UNITED STATES
NUCLEAR REGULATORY COMMISSION
WASHINGTON, D.C. 20555-0001

SUBJECT: TECHNICAL REVIEW OF THE GENERAL SEPARATIONS AREA
2016 AND 2018 PORFLOW MODELS AND ASSOCIATED
DOCUMENTATION SUPPORTING THE F-AREA AND H-AREA
TANK FARM FACILITY PERFORMANCE ASSESSMENTS AT
THE SAVANNAH RIVER SITE, AIKEN, SOUTH CAROLINA
(DOCKET NO. PROJ0734)

Technical Review of 2016 and 2018 General Separations Area PORFLOW Model Documentation

Figure 1 - GSA 2016 Model Residuals UTRA-UAZ (top panel) and UTRA-LAZ (bottom panel) for PEST Simulation 51.

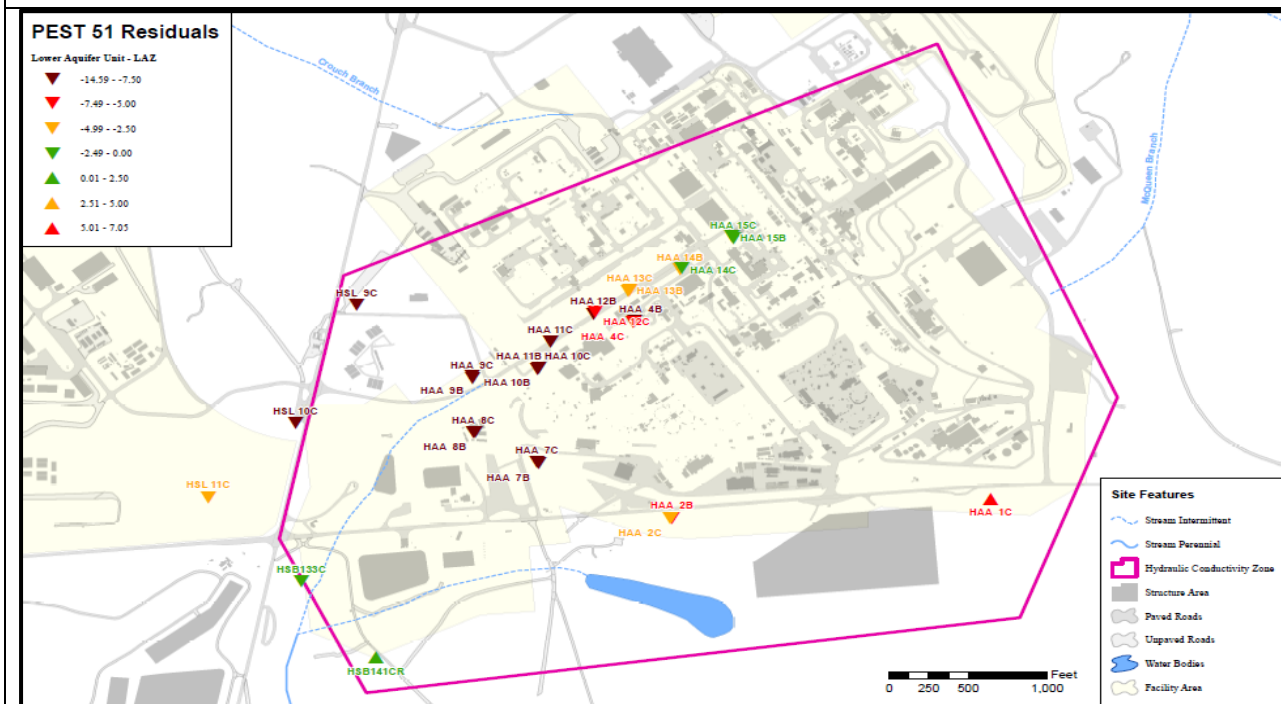
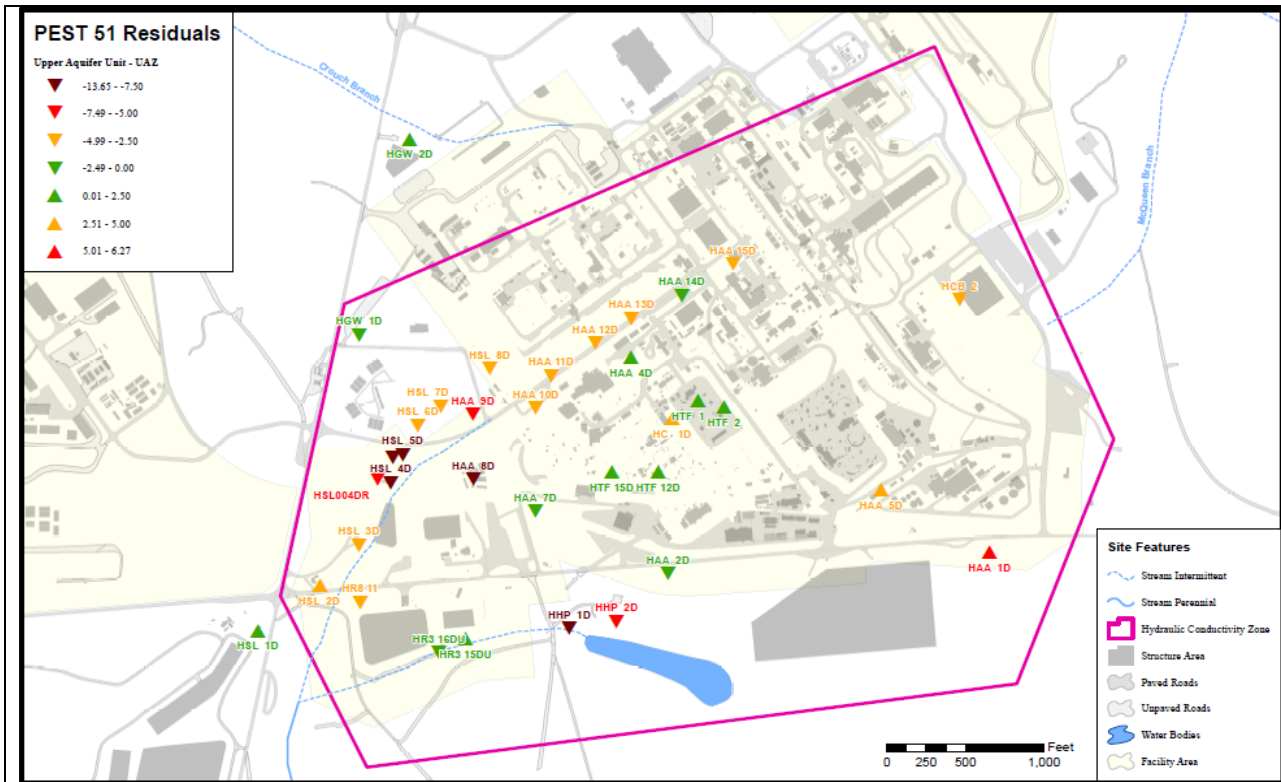
In previous TERs, and more recently in the March 2019 OOV, NRC staff noted that calibration and evaluation of calibration statistics local to the waste disposal facility PA areas of interest (e.g., FTF, HTF, and SDF) would be desirable (NRC, 2014; NRC, 2019). The velocity field for

Figure 3 - Comparison of Particle Tracks from 2004 and 2018 Models with Updated Dispersion Model and Grid Refinement. Image Credit: Figures 2.3-8 and 2.3-10 from SRR-CWDA-2016-00078, Rev. 1.

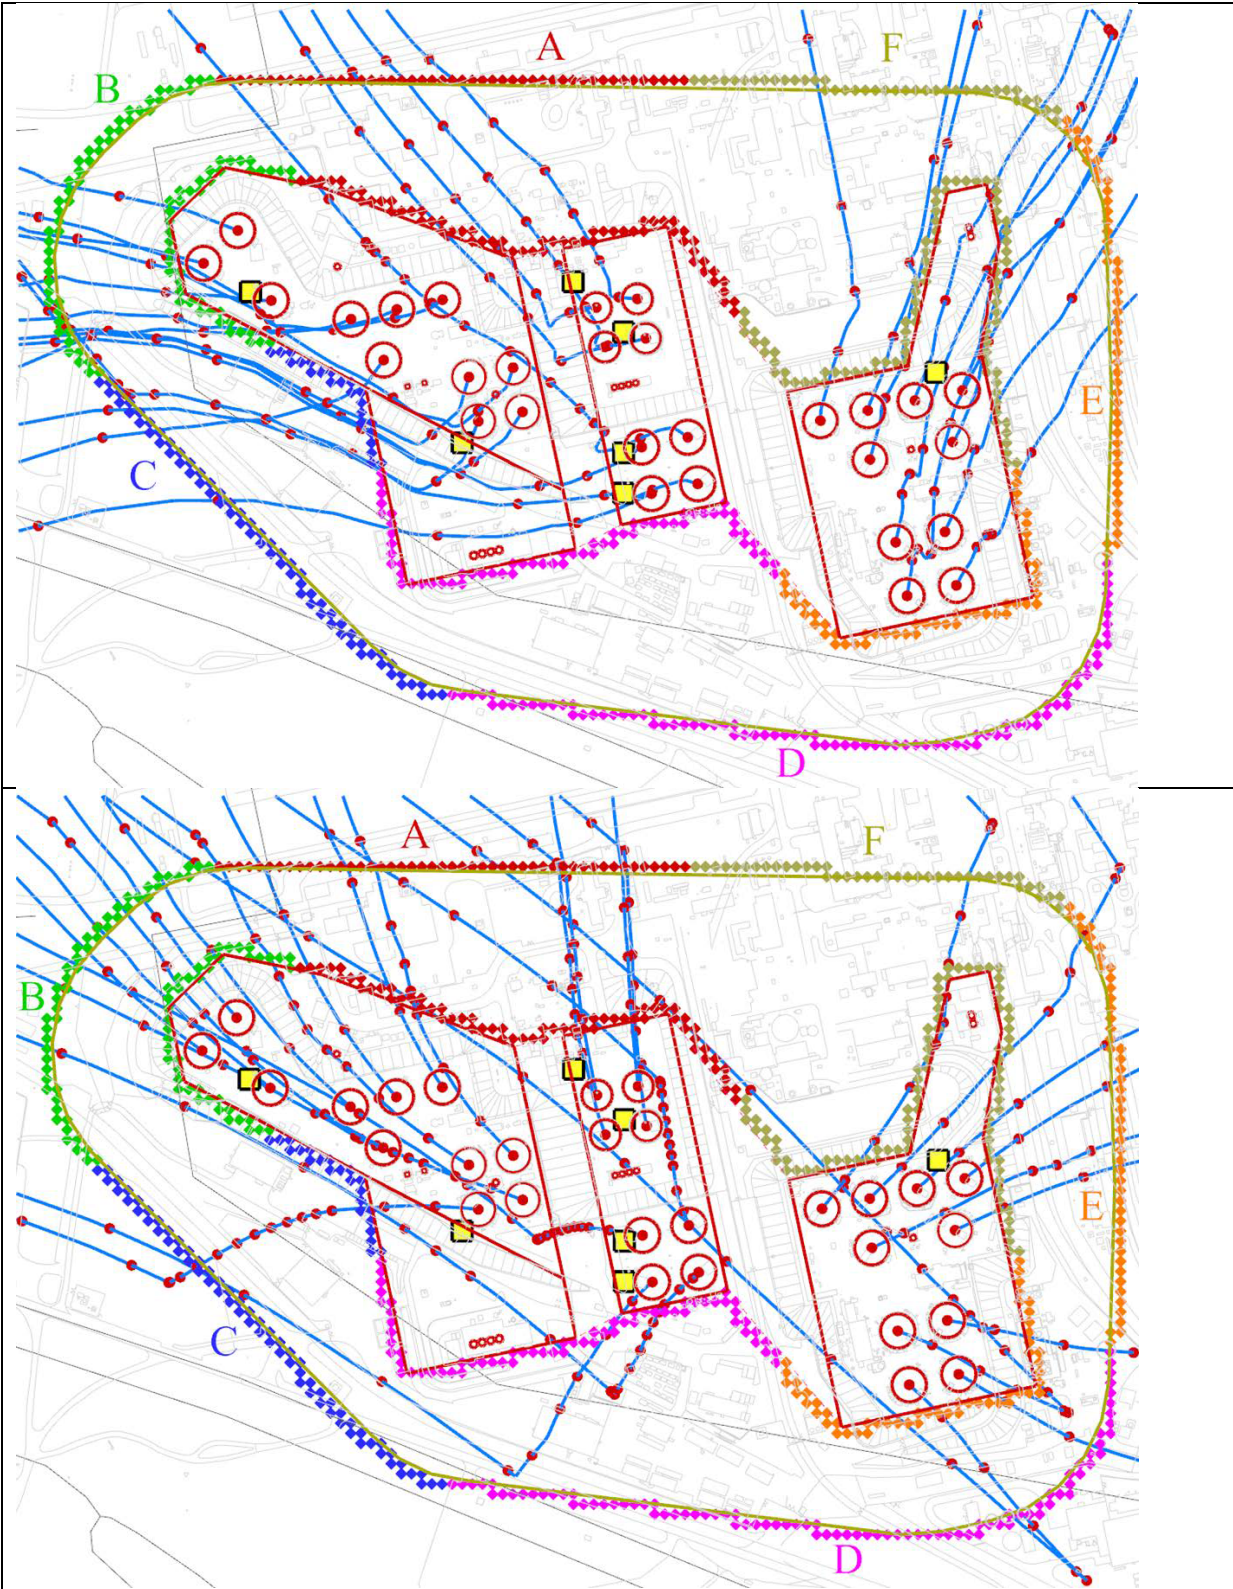
NRC staff note substantial difference in flow rates (signified by the red circles on Figure 3 that represent 10-yr time markers) from many tanks at HTF, and most notably the risk-significant Type II tanks located to the south-central at the tank farm. This result could have a substantial impact on dose associated with relatively short-lived radionuclides in alternative cases (e.g., release of short-lived radionuclides from the annulus of Tank 16 through preferential pathways). Additionally, the change in the HTF model results could be important if risk-significant doses are pushed out beyond the compliance period. Therefore, NRC staff will continue to monitor the impact of the GSA 2018 model in future PA updates, including a more in-depth evaluation of the impact of the new GSA 2018 model on PA results after receipt of the modeling files from DOE.
